Seismic review of a typical low rise commercial building – a case study

ABSTRACT

The Case study building was designed and built in 2003. The building is a single storey rectangular shaped 25m x 21m steel portal frame structure with precast concrete panels. The building is typical of a modern commercial building in New Zealand.

The building was assessed to have a seismic rating below 34%NBS(IL2) and is in the process of being strengthened.

Figure 5: Load path for out-of-plane support of a precast panel on Grid 1

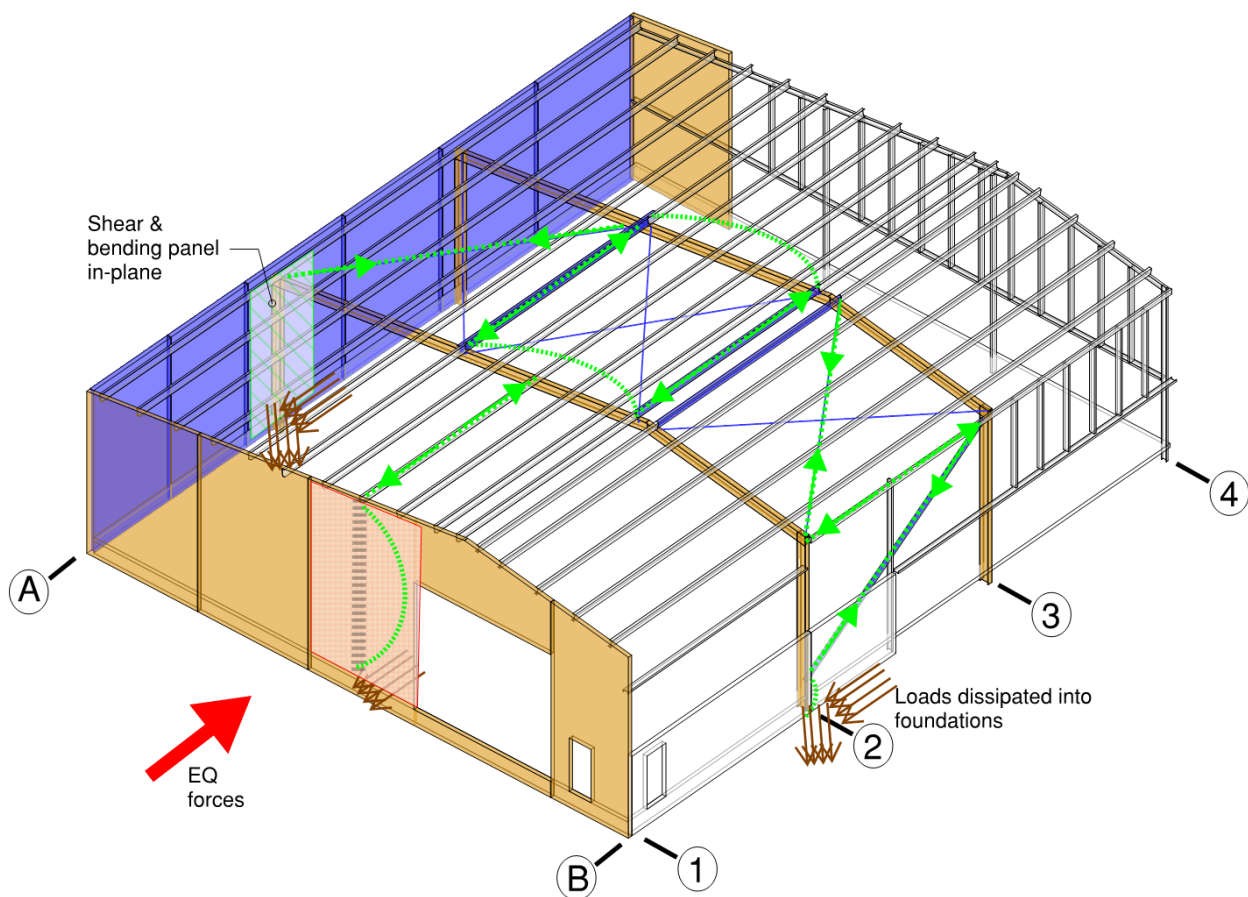
The flags raised when following this load path are as follows.

- The ability of the purlins to act as compression struts and in bending to support the high gable end (Grid 1) concrete panels
- Reliance on the purlins to act as strut members in the roof plane bracing system
- Reliance on weak direction bending of the portal frame rafter to transfer heavy concrete panel loads
- The tension roof bracing loads are resisted by a single panel on Grid A as there is no joint between the panels. It is unlikely that this is acceptable considering the demand on the inserts as well as the reasonably small foundations.
- The resistance available for the uplift component on the foundations when the wall brace is in tension.

Figure 7: Load path for out-of-plane support of a precast panel on Grid A

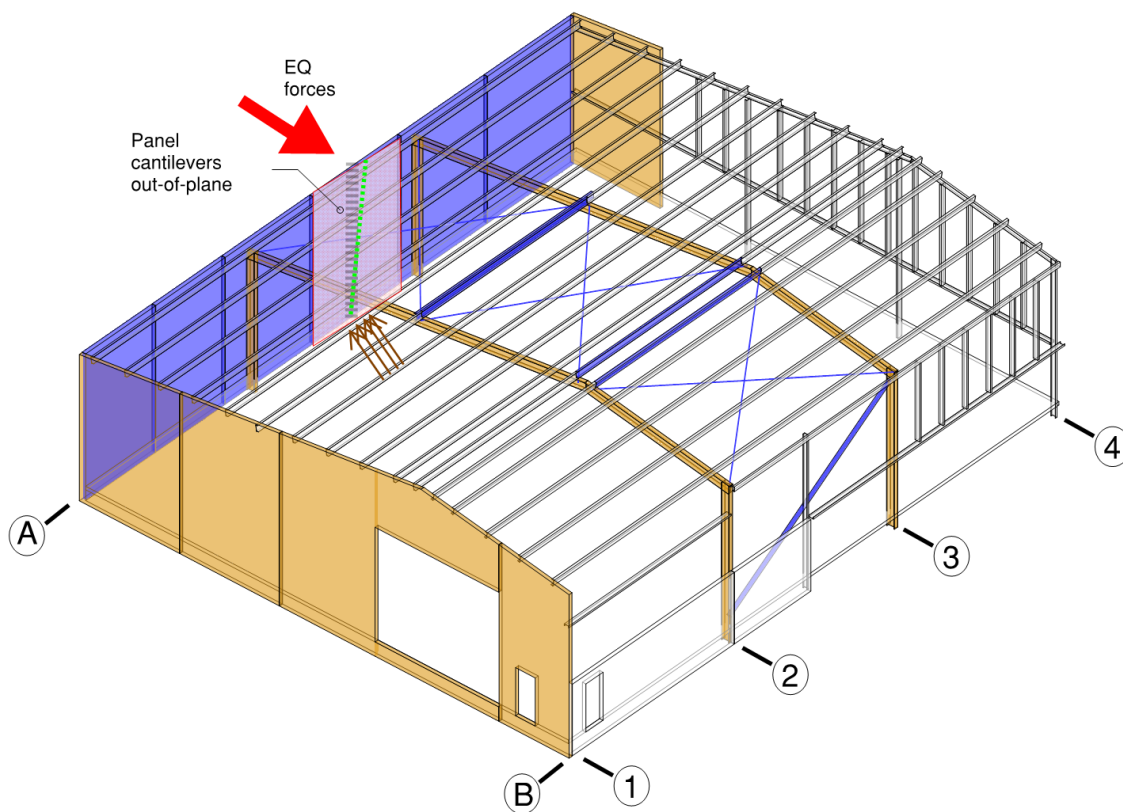
In our global review, it was assumed that the primary load resisting system is the portal frames, and in-plane end walls on Grid 1 and 4. However, on inspection of the structural plans it is noted that there is no collector to support the panels at the top. While there are some smaller weld plates, these are nominal in size only.

This means the only available load path to resist seismic loads is via the panels cantilevering from their base.

The flags raised when following this load path are as follows.

- A 150mm thick precast panel is unlikely to be able to cantilever 6m in a high seismic zone.

Figure 9: Connection of precast panels to strut

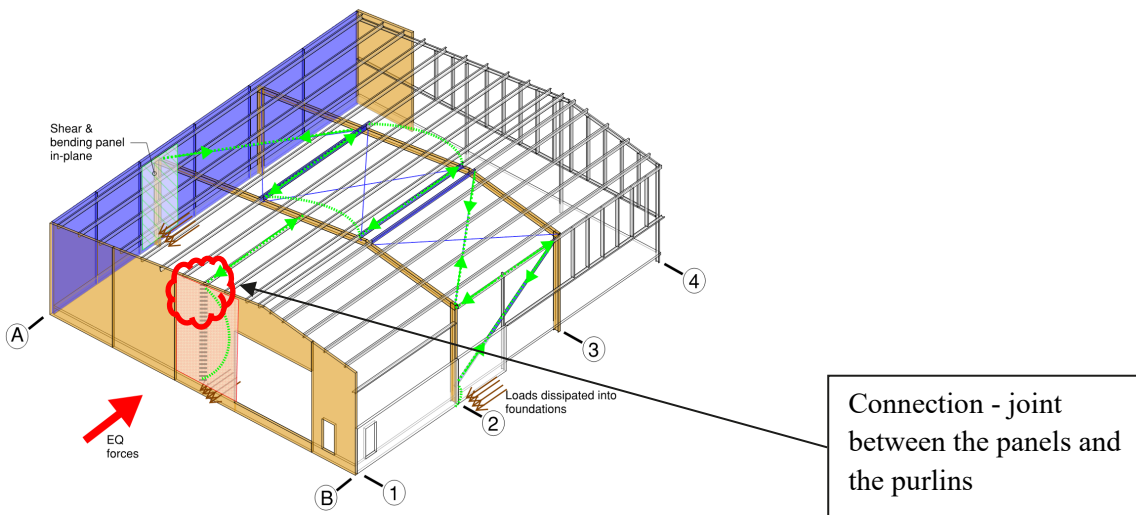
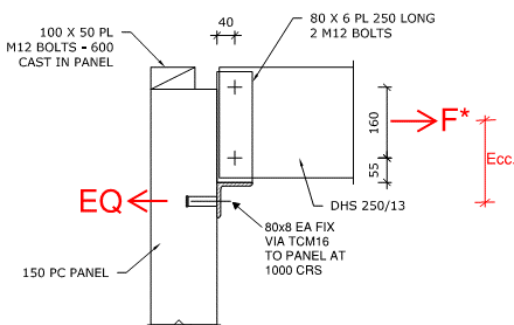
As can be seen, the connection has the following issues identified from a visual review. No calculations are needed to identify these deficiencies; however, calculations would be necessary to confirm the capacity of the connection.

- Highly eccentric connection
- The capacity of the bolts in the thin-walled purlin steel section will likely limit how much load can be transferred to the purlin (tear out)
- The TCM16 inserts are at 1m centres, so the EA must act in bending to transfer loads to the strut cleats
- The cleat bending and weld to the EA
- The pull-out capacity of the TCM insert, which are non-seismic rated
- Prying action at the insert

It should also be noted that this connection is relied on to transfer loads in the other direction, ie roof loads need to be transferred to the concrete panels in-plane on Grid 1. This connection is also deficient for loads in this direction.

Figure 13: Completed elevated and plan view of connection of purlin struts to tension-only bracing noting eccentricities

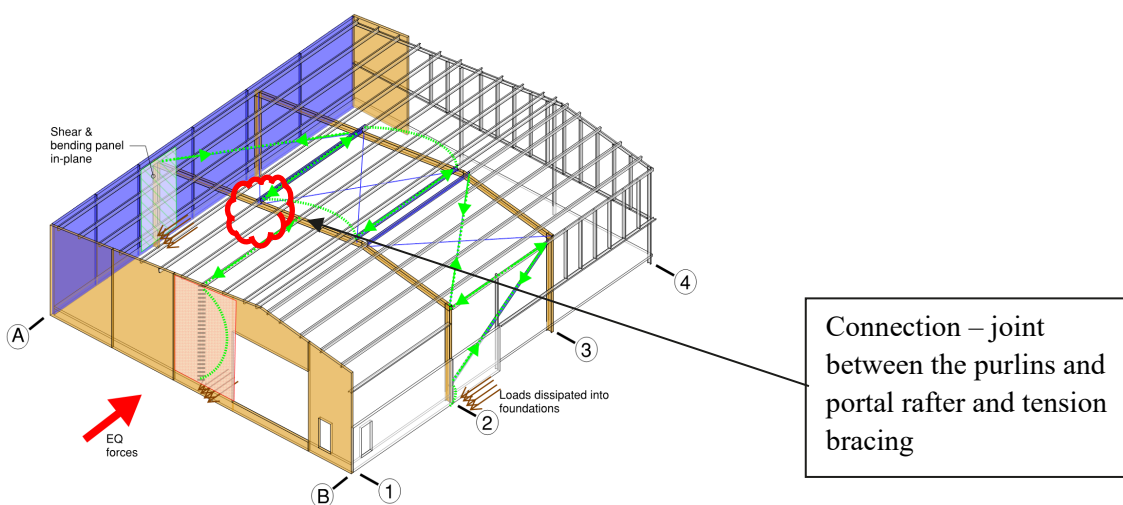
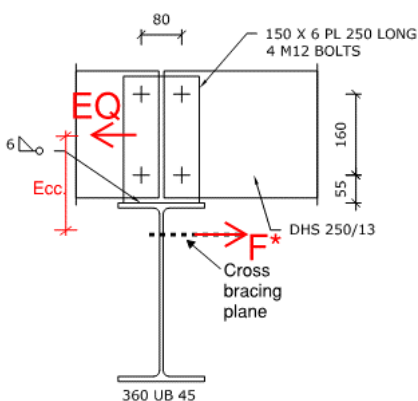
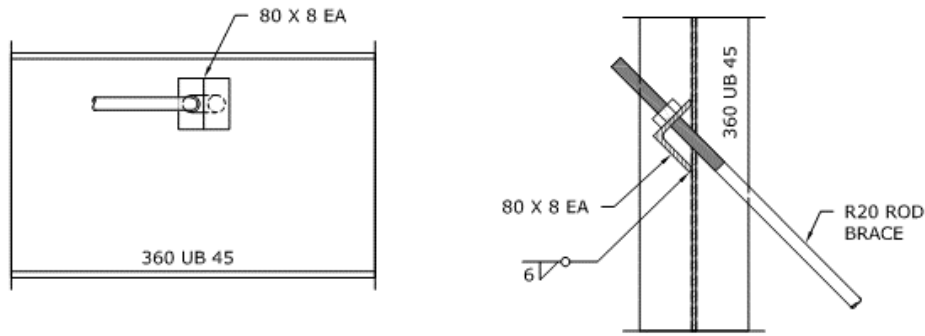
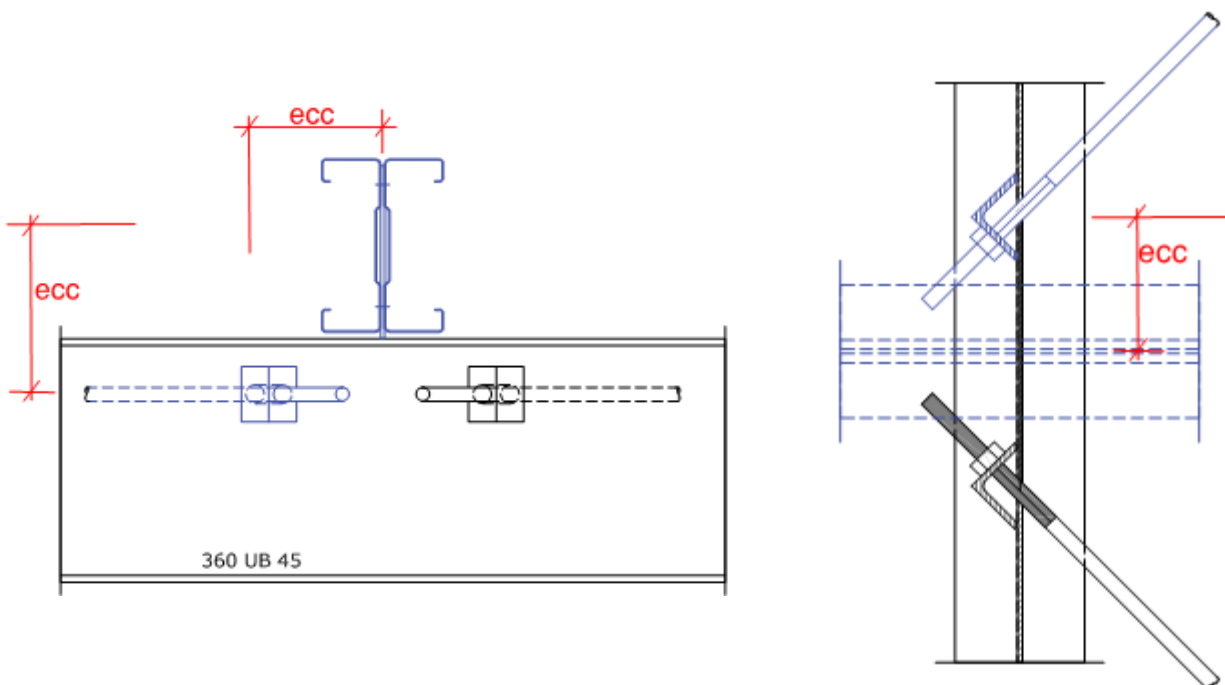
As can be seen, the connection has the following issues identified from a visual review.

- Eccentric connection with both vertical and horizontal offsets between the point of applied loads and the point of resistance.
- A reliance on indirect load path (web bending) to transfer loads
- The capacity of the bolts in the thin-walled purlin steel section will likely limit how much load can be transferred to the purlin (tear out)
- The cleat bending and connection to the UB

Structural details are for individual components (see figure 11 and 12), however when the collated load path detail is drawn the eccentricities become clearer (see figure 13).

Figure 15: Connection of tension brace to strut in section (left) and elevation (right)

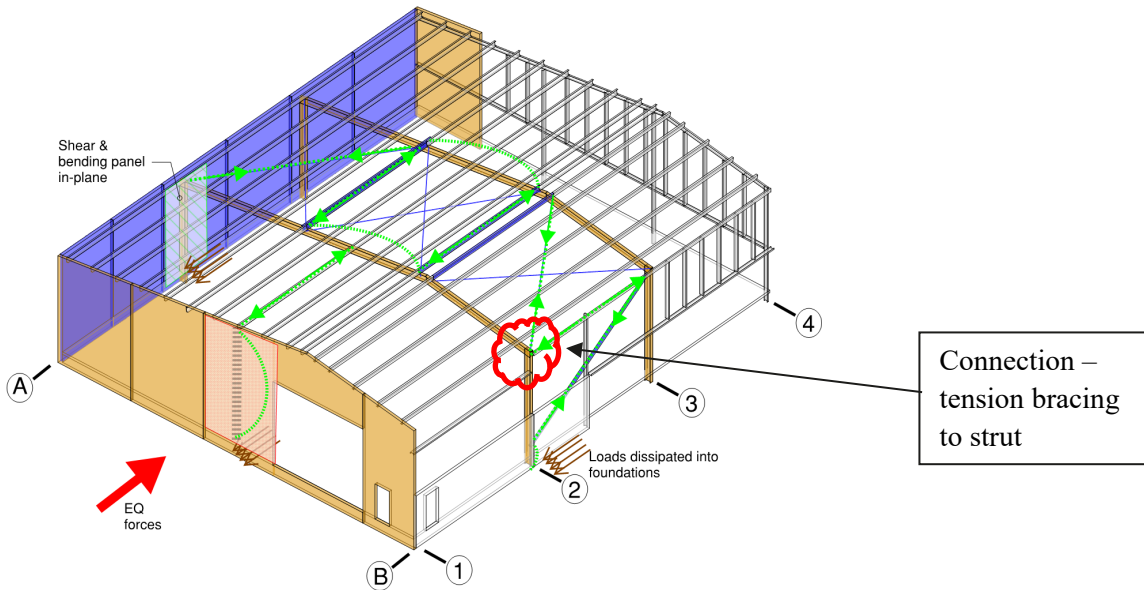
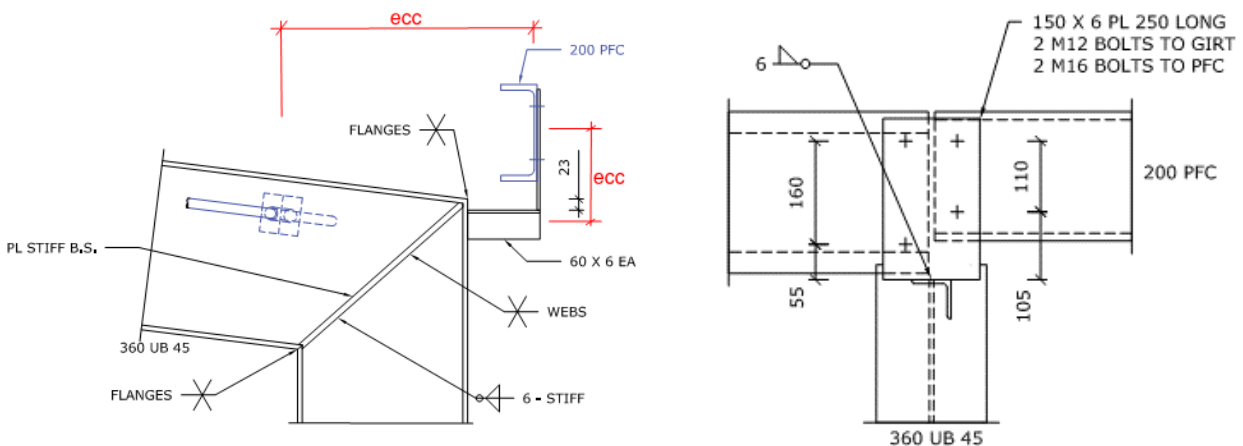
As can be seen, the connection is extremely eccentric and relies on multiple indirect load paths to transfer loads.

- Eccentric connection with both vertical and horizontal offsets between the point of applied loads and the point of resistance.
- A reliance on cantilever bending and torsion of a 60x6 EA stub
- Loads to be transferred through the knee joint arrangement
- M16 bolts specified, with no grade.

The poor detailing of this joint would make quantifying the joint capacity difficult.

Figure 17: Connection of tension brace to strut (details from plans, blue elements added for clarity)

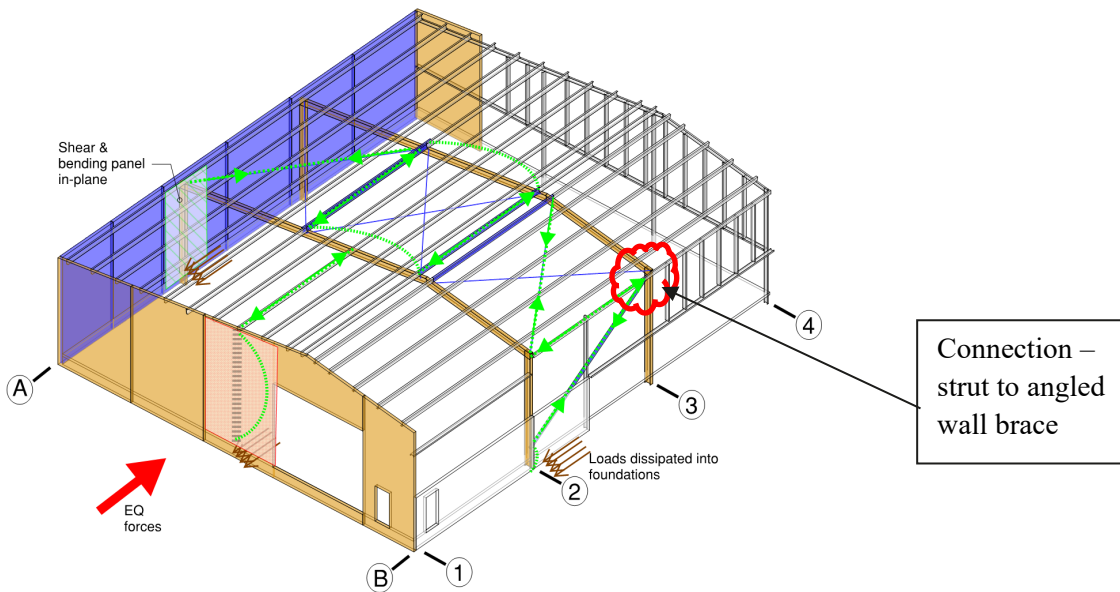
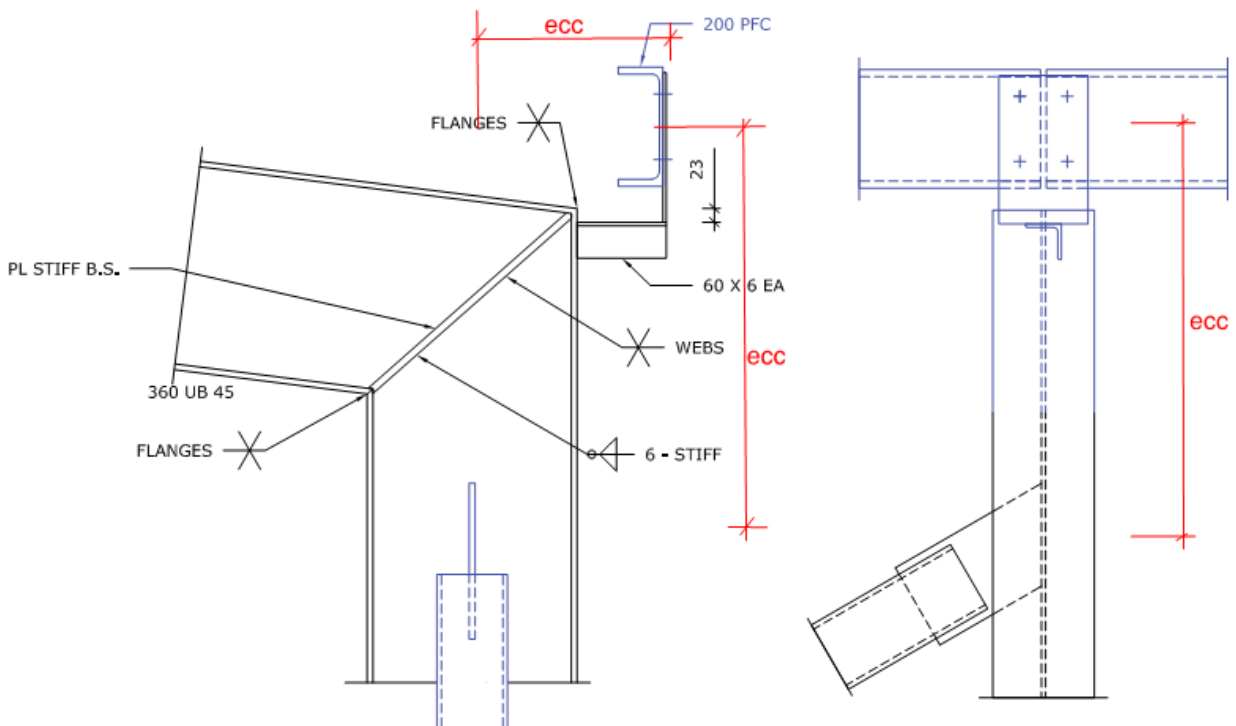
As can be seen, the connection is extremely eccentric and relies on multiple indirect load paths to transfer loads.

- Eccentric connection with both vertical and horizontal offsets between the point of applied loads and the point of resistance.
- A reliance on cantilever bending and torsion of a 60x6 EA stub
- Weak direction bending of the portal column
- Cleat bending and connections
- M16 bolts specified, with no grade.

The poor joint detailing makes quantifying the joint capacity difficult.

Figure 20: Connection detail at base of panels on Grid A

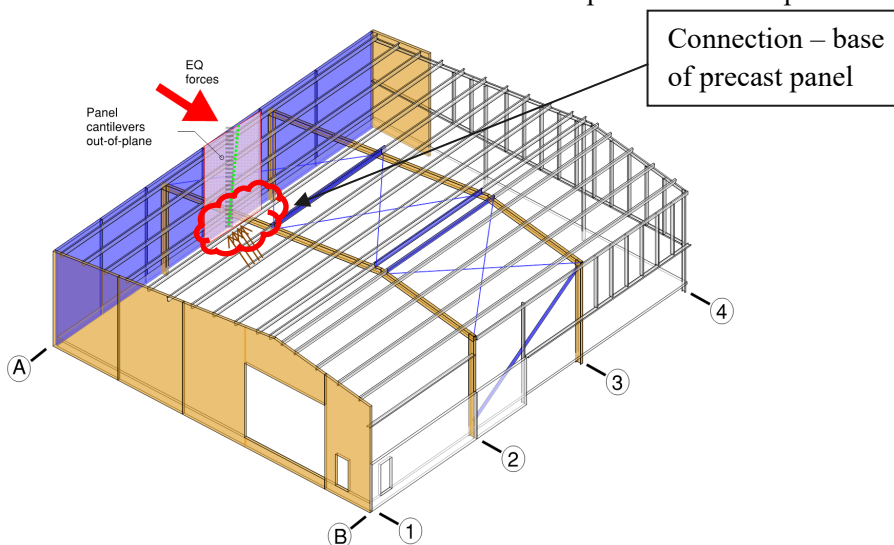
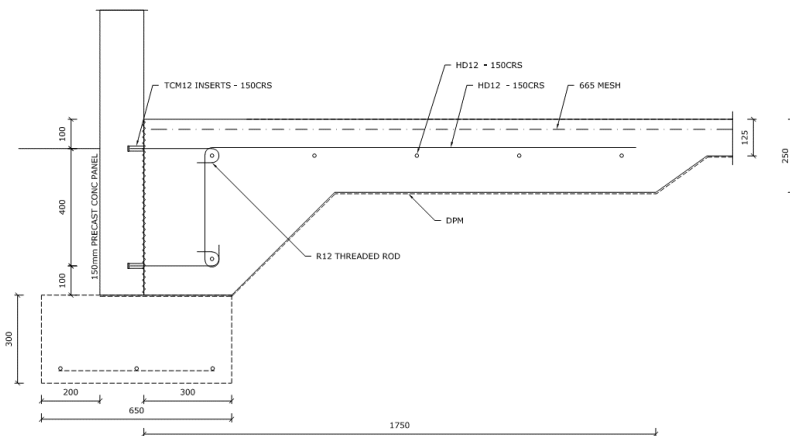
A review of the drawings shows that there is a proprietary insert present. An engineer would usually assume a typical proprietary panel type connection, however on closer inspection of the plans it is seen that a TCM12 insert is specified, not a RB12. These inserts are a significantly smaller threaded rod insert, as seen in the image below.

Recent research has highlighted the poor performance of this configuration of the proprietary panel insert connection, with a reliance on concrete to act in tension (Hogan 2018). This configuration of a threaded rod insert detail will fail when the panels reach reasonably low levels of drift (Hogan 2018).

The detailing around the footing highlights the following concerns.

- TCM12 inserts with very shallow embedment into the precast panel
- Poor detailing with limited ability to develop the footing reinforcing
- The threaded rod is of uncertain material.
- The footing size is relatively small compared to the panel size and may not be adequate for overall stability. If the slab is required for additional capacity, the fixing between the two, particularly to transfer tension forces from the bottom footing reinforcing bar, is poor.

It should be noted that this detail is likely to be unacceptable for a post-fire stability load even once remediation of the seismic structure is completed.

Figure 22: Connection detail at base of panels on Grid A

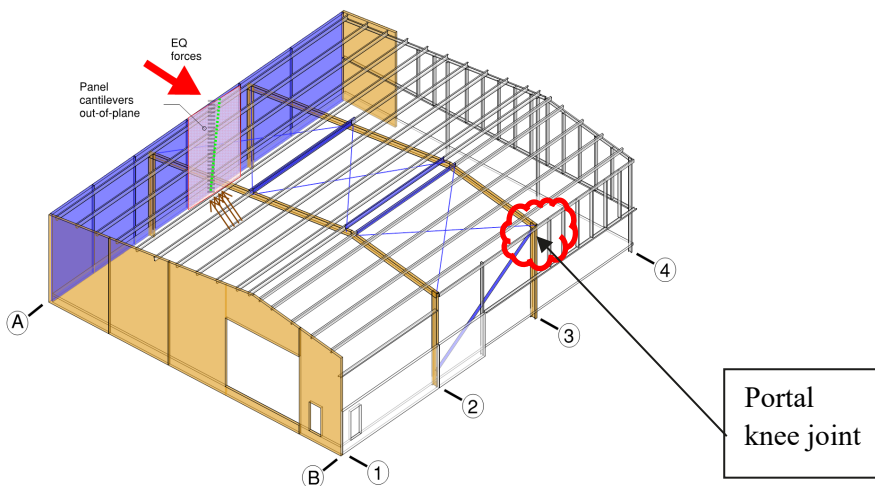
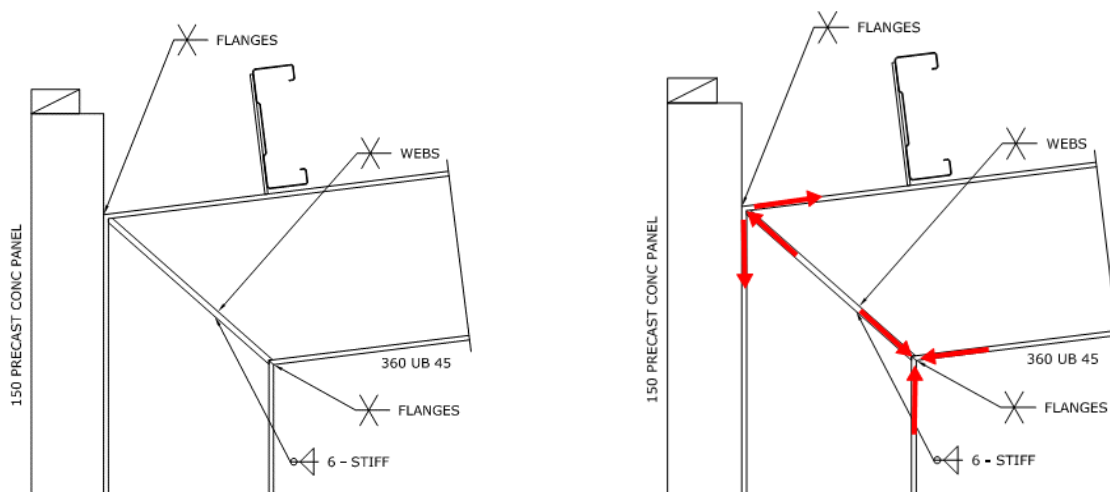
The detailing around the knee joint highlights the following flags.

- A 10mm Grade 250MPa plate is unlikely to resist the forces from two 9.8mm Grade 320MPa flanges
- No lateral restraint to the inside flanges of the column
- The quality of the butt weld to the flanges at an acute is difficult to achieve and may not be covered under AS/NZS5131

Basic calculations show that the knee joint capacity is significantly lower than the section capacity.
